## Seabed Pipeline Route for Clover Point Forcemain

Please find attached a technical memo developed by Stantec Consulting Ltd, which responds to a seabed proposal route for the Clover Point Forcemain.

**Reference: Seabed Pipeline Route for Clover Forcemain – John Gunton, BSc., Ph.D  
Letter of March 3, 2017**

Figure 1. Multibeam swath bathymetry image of northern Strait of Juan de Fuca adjacent to the city of Victoria, showing mapped active faults of the DMFZ. Locations of Figures 3 and 4 are shown.

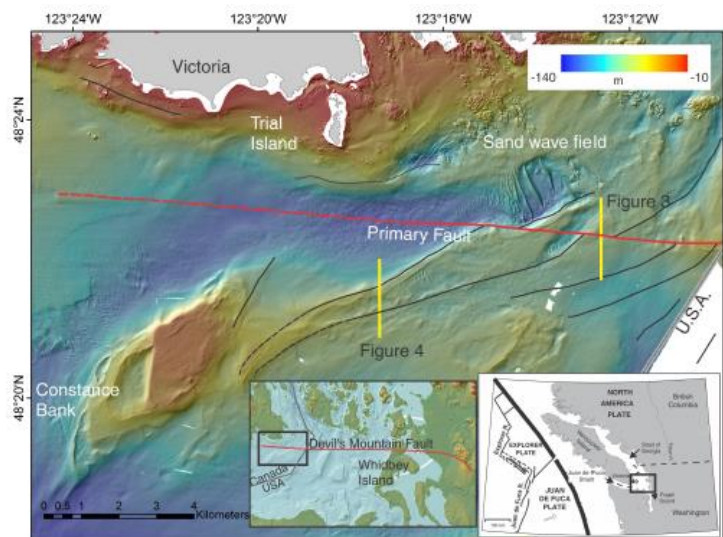
- Location of Fault Line** – The known fault line that is referenced offshore from Victoria comes from a 2015 Geological Survey of Canada report by J.V. Barrie and H.G. Green titled Active faulting in the northern Juan de Fuca Strait: implications for Victoria, British Columbia (GSC Current Research 2015-6). The authors used multi-beam echo sounder swath (MBES) bathymetry to produce high-resolution sub-bottom profiles to identify a main strand, primary, and secondary (conjugate) faults of the Devil's Mountain Fault Zone. Core samples were also taken and analyzed.

The mapped active faults are shown in Figure 1 (above) and their methods are described in the GSC 2015 report along with the authors' results of the detailed survey work near Victoria.

The GSC 2015 report does state that further survey data are required to map the western extent of the DMFZ directly offshore of Victoria and Esquimalt.

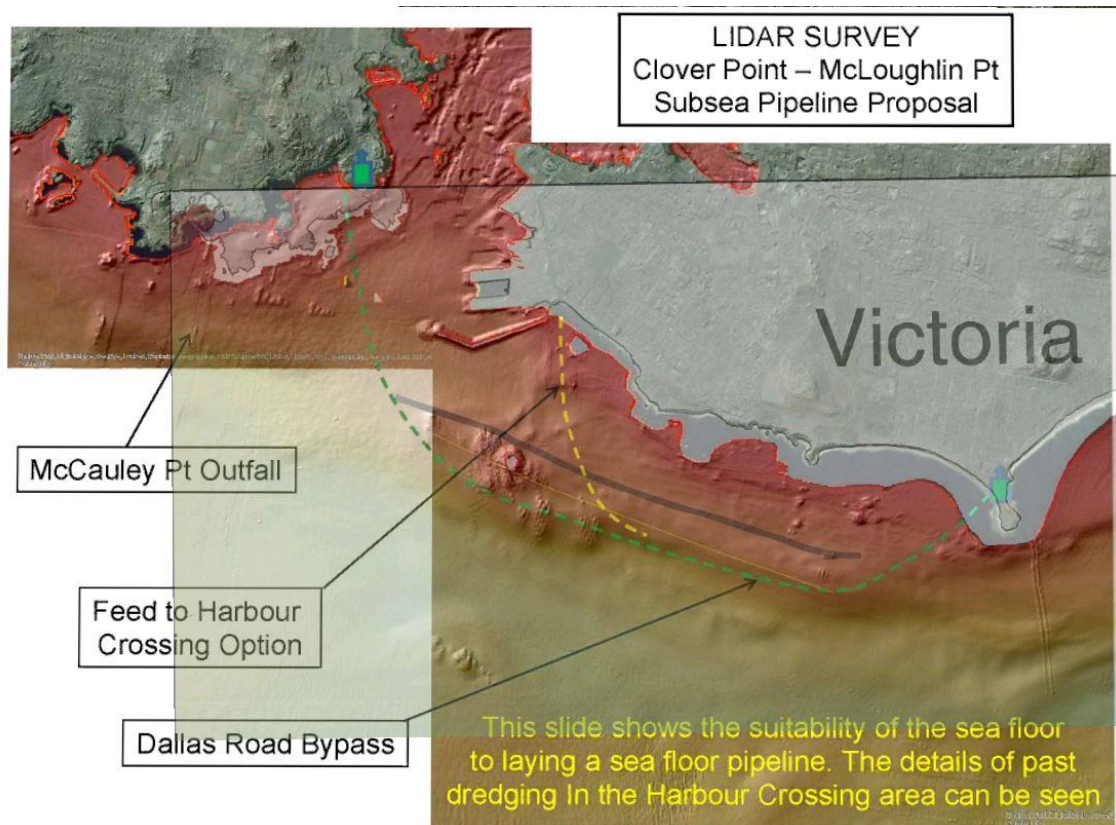
Finally, an approximate overlay (below) of Mr. Gunton's seabed pipeline alignment is presented with the GSC fault mapping.

The figure above shows that the proposed yellow line seabed pipeline alignment appears to cross the secondary fault identified by the GSC 2015 report and the green pipeline alignment is also very close to the fault.
